MANDATORY SERVICE BULLETIN**NUMBER:** SB-010 **AMENDMENT 1****DATE:** 06/09/2009**SUBJECT:** FUSELAGE; VERTICAL TAIL BOLT INSPECTION **AMENDMENT 1****SUMMARY**

**SB-010 Vertical Tail Bolt Inspection
AMENDMENT**

Figure 1 - Bolt Locations

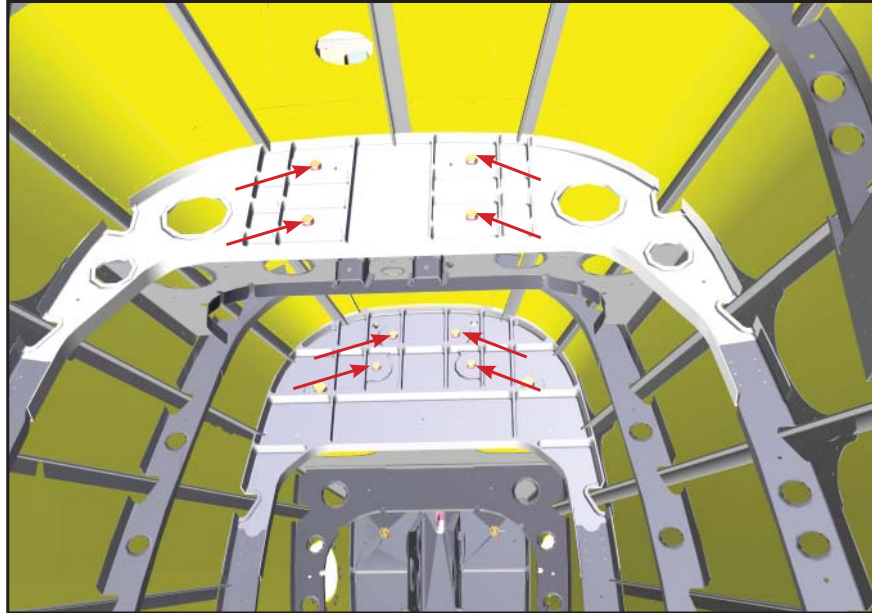
See **Figure 1** for assistance in identifying these 8 bolts within the vertical tail. **Figure 2** shows a close-up view of the bolts that must undergo inspection.
